REMARKS

Favorable reconsideration of the above-identified application, in view of the foregoing amendments to the description and Abstract, and the amendment to the drawing detailed hereinafter, and in view of the following remarks, is respectfully requested.

FIG. 1

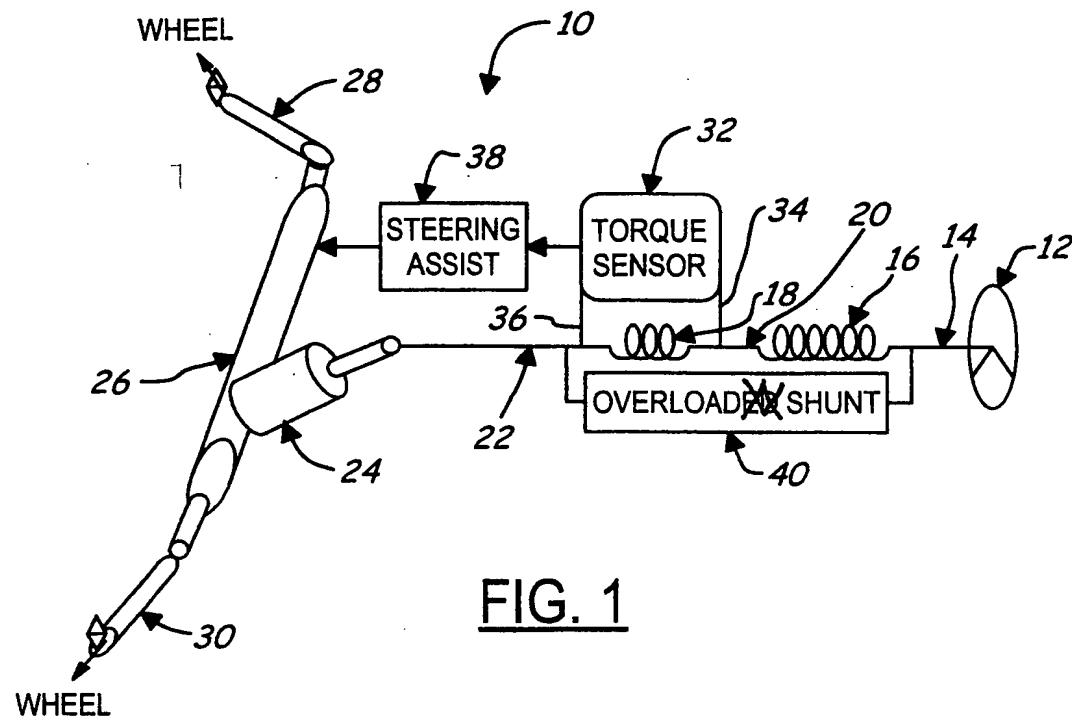
With reference to the drawing amendment, a corrected drawing sheet is submitted herewith in which FIG. 1 has been amended to correct the labeling of overload shunt 40 from "overloaded shunt" to "overload shunt". A copy of the original drawing sheet containing FIG. 1 is enclosed with this correction indicated in red ink thereon.
